Our Ref: K-2578-IRR-001
Your Ref: OP3043/2019
Date: 31 May 2019

Re: Information Request – Operational Works – 12 Crawford Street, Mossman

Response

LOT 3-4 OVERLAND FLOW PATH DETAIL
SCALE 1:100 (A1)

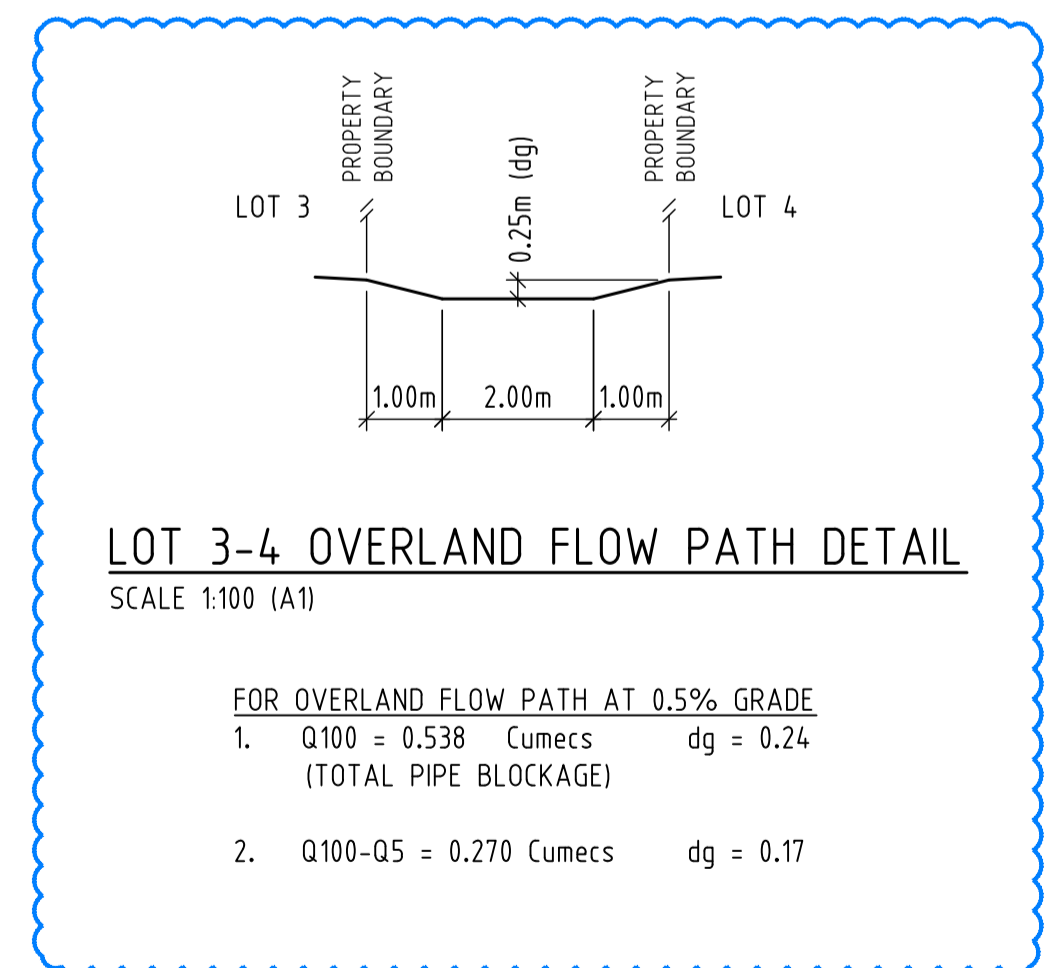
17. The earthworks grading indicates stormwater from Lot 3 mostly discharges to Lot 4. Please clarify, how it is intended to protect Lot 4 from Lot 3 stormwater.

The earthworks plan shows most of Lot 3 falling to the internal road and with the southern part grading so as to fall to Parker Creek between Lot 3 and Lot 4.

FOR OVERLAND FLOW PATH AT 0.5% GRADE
 1. Q100 = 0.538 Cumecs dg = 0.24
 (TOTAL PIPE BLOCKAGE)
 2. Q100-Q5 = 0.270 Cumecs dg = 0.17

JOB No: **K-2578**
SHEET: **C04 | E**
SCALE: 1:500H 1:100V (@ A1)

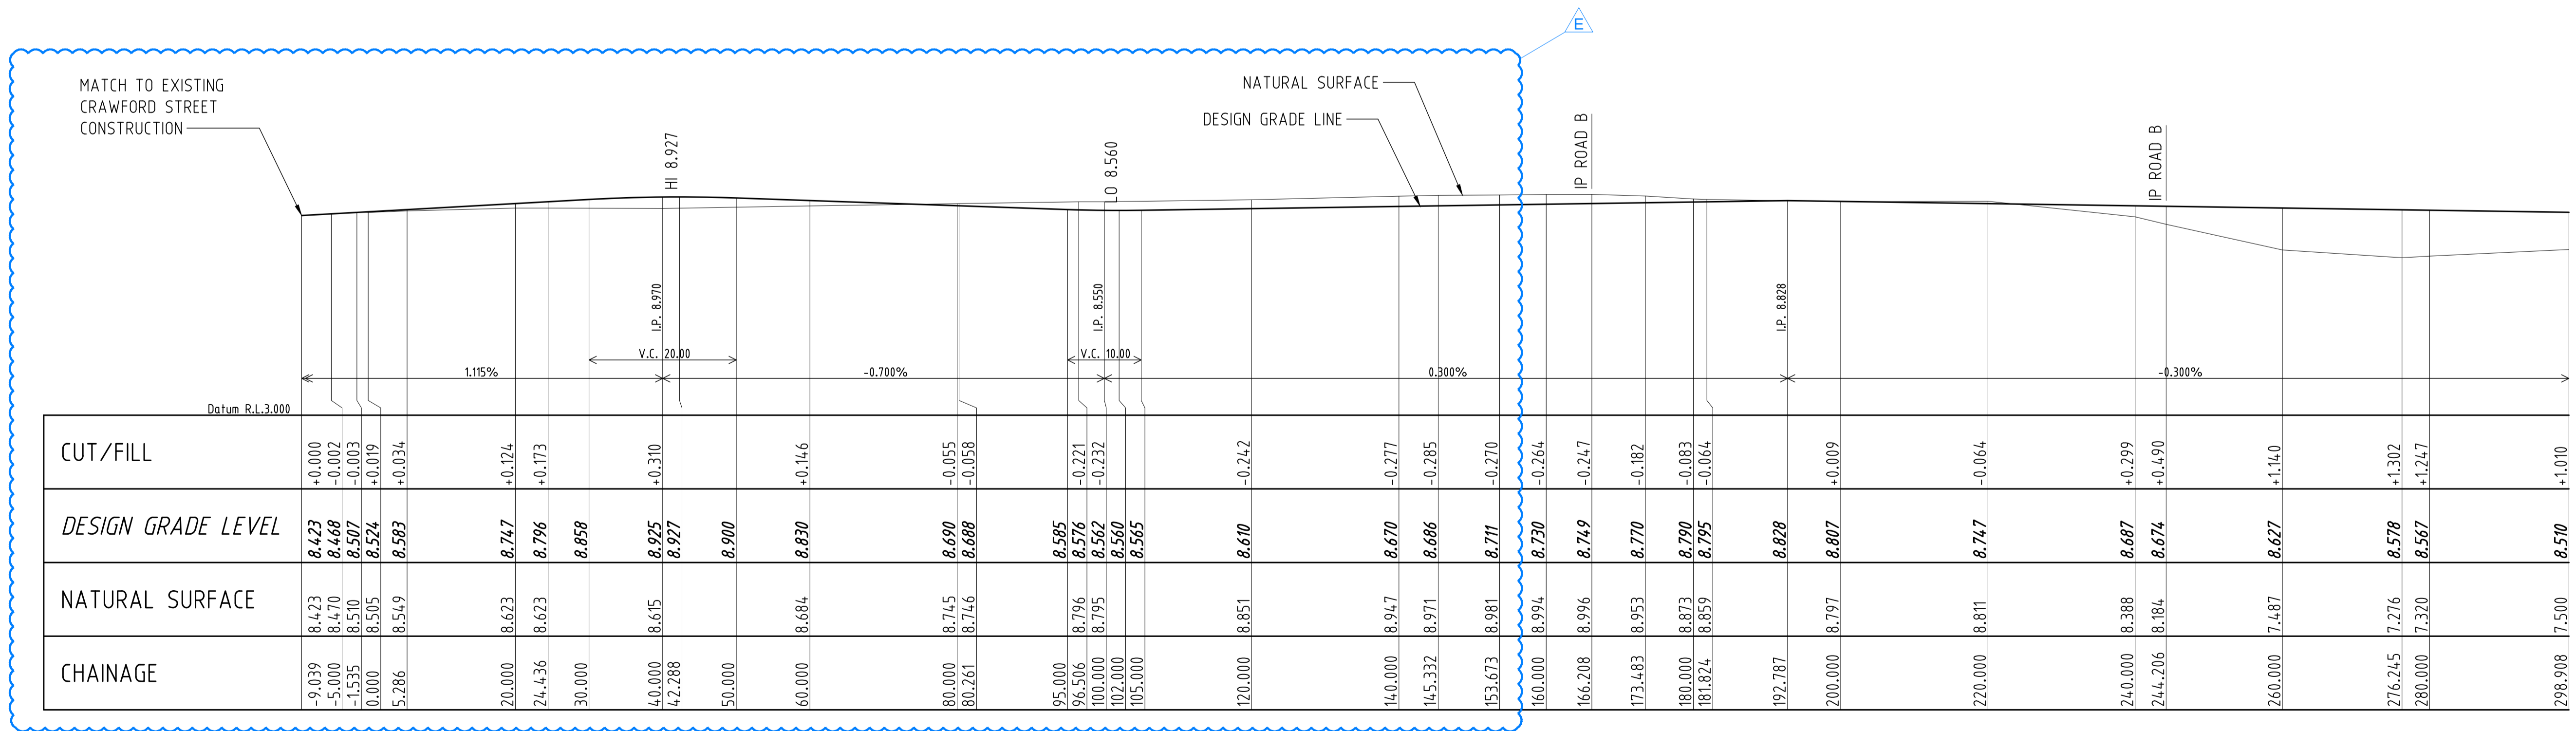
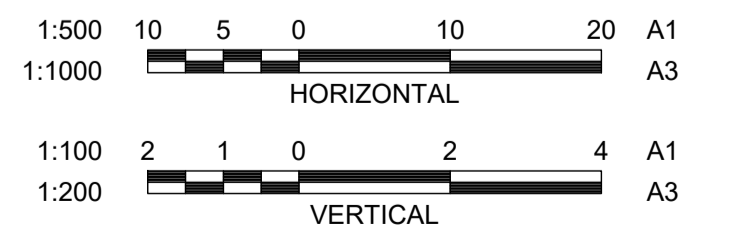
With reference to FNQROC D1.06, Council does not approve the proposed road gradient of 0.3%. The gradient is to be increased to a minimum of 0.5%. Please provide amended engineering drawings to reflect this change.

No.	DATE	ISSUE / REVISIONS	EWK	EFB
D	23/05/19	ROAD A REGRADED		
C	30/04/18	REDESIGN FOR NEW DESIGN LEVELS		
B	29/11/16	REVISION FOR NEW Q100 FLOOD LEVEL - TENDER ISSUE		
A	18/07/16	ORIGINAL ISSUE

JOB No: **K-2578**
 SHEET: **C07 | D**
 SCALE: 1:250 (@A1)

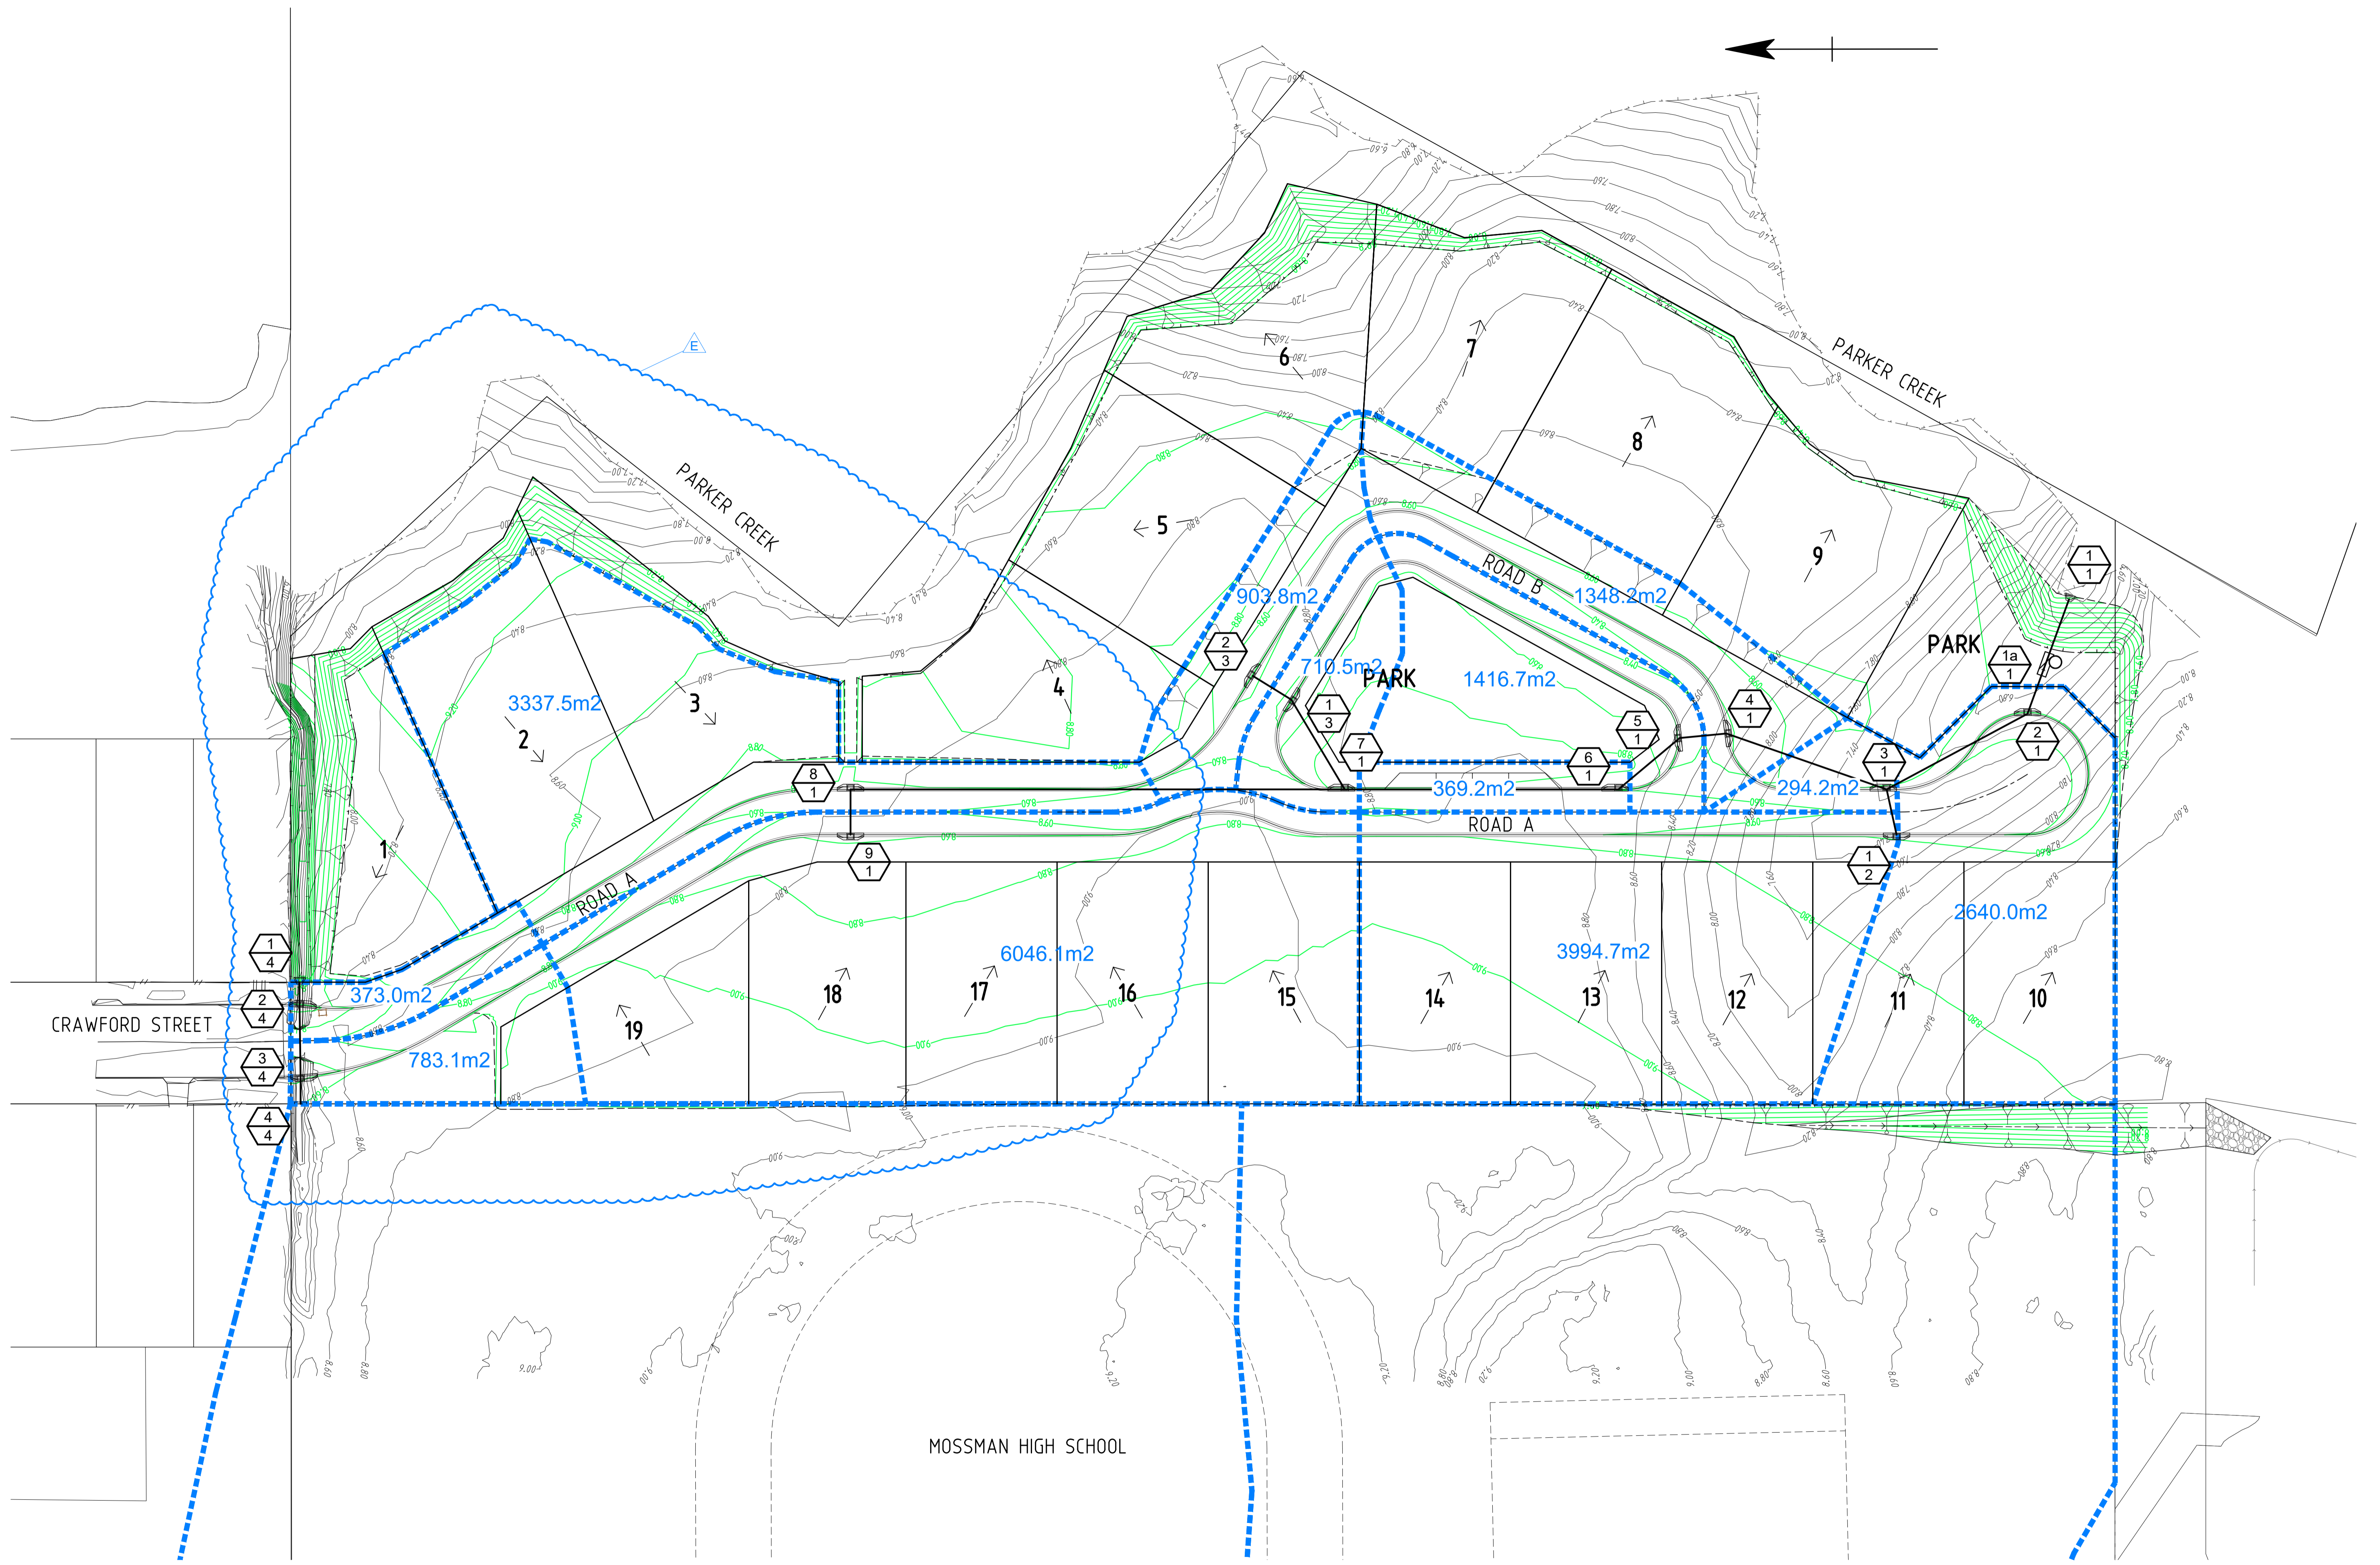
- 3. The Traffic Island proposed near Road A Chainage 0m is not supported by Council . Please remove this from the Engineering Drawings. It is noted that no street lighting was proposed and the island would not have been compliant. Council seeks clarification on why this was certified by the RPEQ.**

We will remove the Traffic Island from the Engineering Drawings, but comment as follows:

D	23/05/19	TRAFFIC ISLAND REMOVED & ROAD A REGRADED		
C	30/04/18	REDESIGN FOR NEW DESIGN LEVELS		
B	29/11/16	REVISION FOR NEW Q100 FLOOD LEVEL - TENDER ISSUE		
A	18/07/16	ORIGINAL ISSUE		
No.	DATE	ISSUE / REVISIONS	EWK	EFB
			DRN	CHKD
DRAWING FILE:		XREF FILE: N/A
